CITY OF EL PASO, TEXAS
PLANNING, RESEARCH & DEVELOPMENT DEPARTMENT

MEMORANDUM

SUBJECT: Council Agenda Item (Ordinance)
Introduction: May 25, 2004
Public Hearing: June 8, 2004

AN ORDINANCE AMENDING THE 2025 PROPOSED THOROUGHFARE SYSTEM AS DETAILED IN THE MAP ATLAS OF THE PLAN FOR EL PASO AND ITS RELATED DOCUMENTS AS ORIGINALLY APPROVED BY THE EL PASO CITY COUNCIL IN 1999, AND AS SUBSEQUENTLY AMENDED. (Riverbend Dr.)

Exhibit A

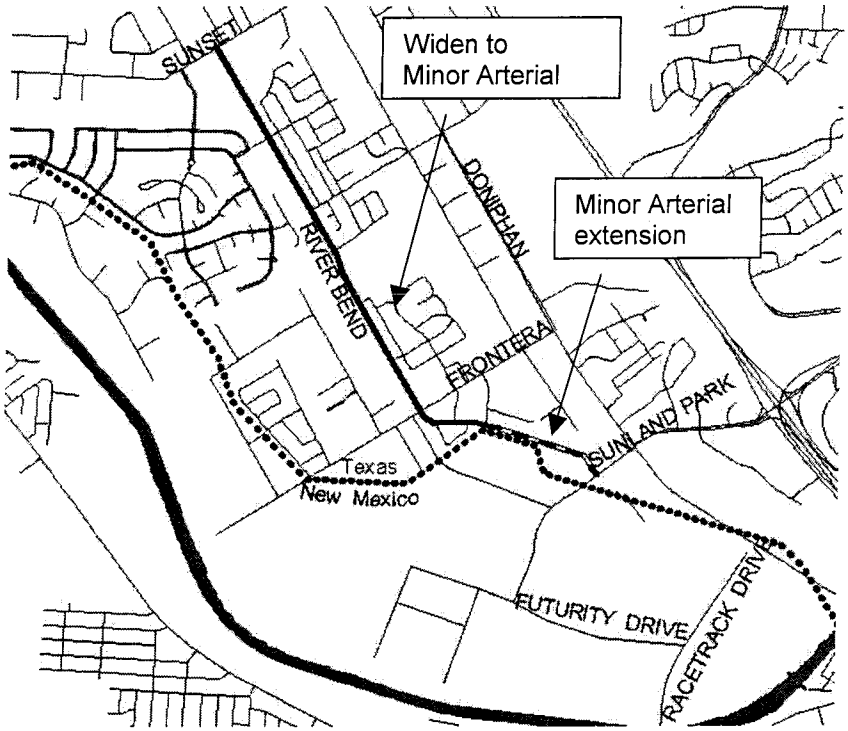
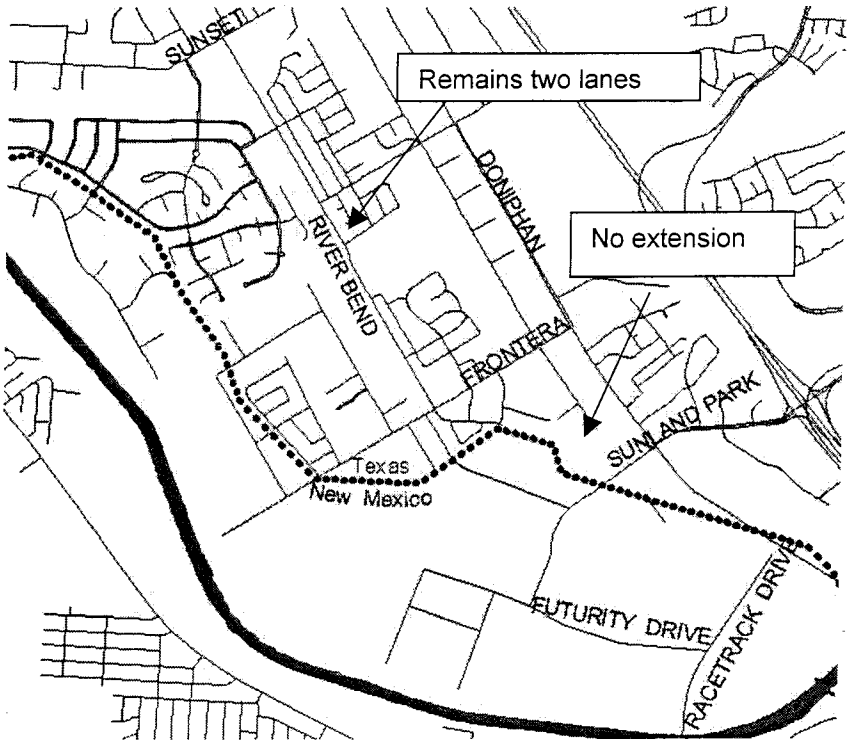
- Amend the 2025 Major Thoroughfare System map by deleting the minor thoroughfare Riverbend Drive between Sunset Drive and Little Lane and its proposed extension to Sunland Park Drive.
